Subject: IMC Phosphates Company (New Wales)
Withdrawal of PSD Construction Permit Application
DAP 1 Plant Project PSD-FL-331
1050059-039-AE

Subject: IMC Phosphates Company (New Wales)
PSD Construction Permit Application
DAP 1 Plant Production Increase

Re: DEP File No. 1050059-039-AC; PSD-FL-331
Granular Monoammonium Phosphate (MAP)/Diammonium Phosphate (DAP) Production Increase
New Wales Facility

BPIP Building Downwash of IMC NEW WALES DAP PLANT #1
POLK COUNTY, FLORIDA 8/02'

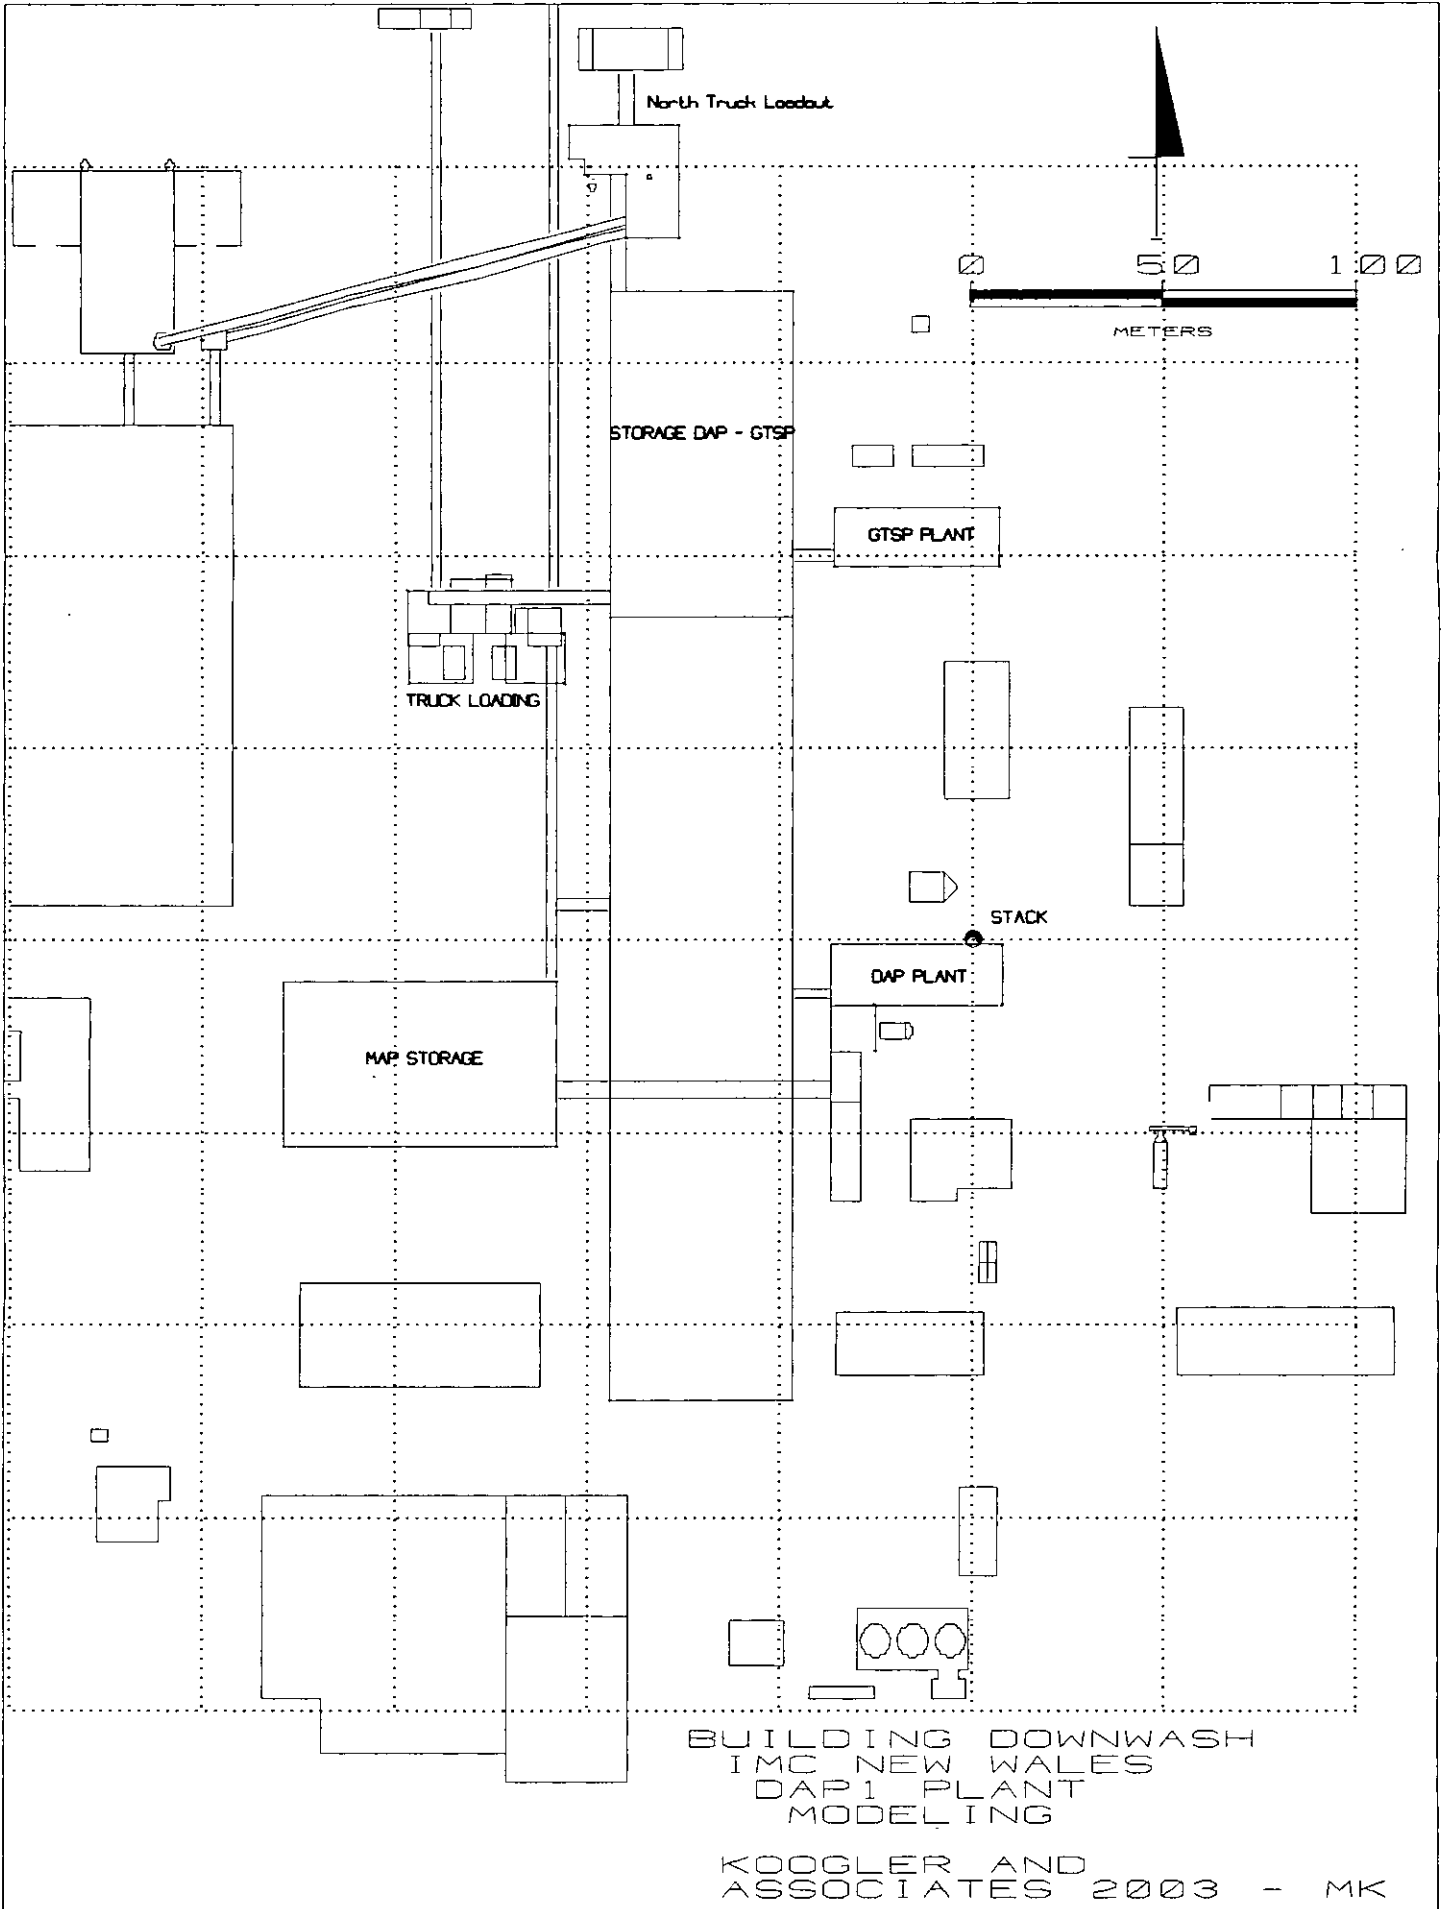
14. The building information contained in the application is inadequate. Please provide the detailed building structure information used in the modeling to determine downwash impacts. This information should include building dimensions for all buildings used in the modeling analyses and BPIP files. In addition, please provide a detailed plot plan to scale of the facility showing the exact location in meters from the modeling origin of each building and stack. All stacks and buildings should be labeled. In addition, a grid with 50 meter spacing should be overlaid over this plot plan so that the information on the plot plan can be easily correlated with the information in the BPIP files.

Information on the modeling inputs is attached (documentation of information previously submitted with R.O. and P.E. certification).

Structure	Height	Length	Width
DAP PLANT	38.1	16.8	48.1
STORAGE DAP - GTSP	24.4	284.9	47.5
MAP STORAGE	27.4	42.9	71.1
GTSP PLANT	38.1	16.1	43.6
TRUCK LOADING	43.6	13.6	11.0
NORTH TRUCK LOADOUT	43.6	10.2	7.4
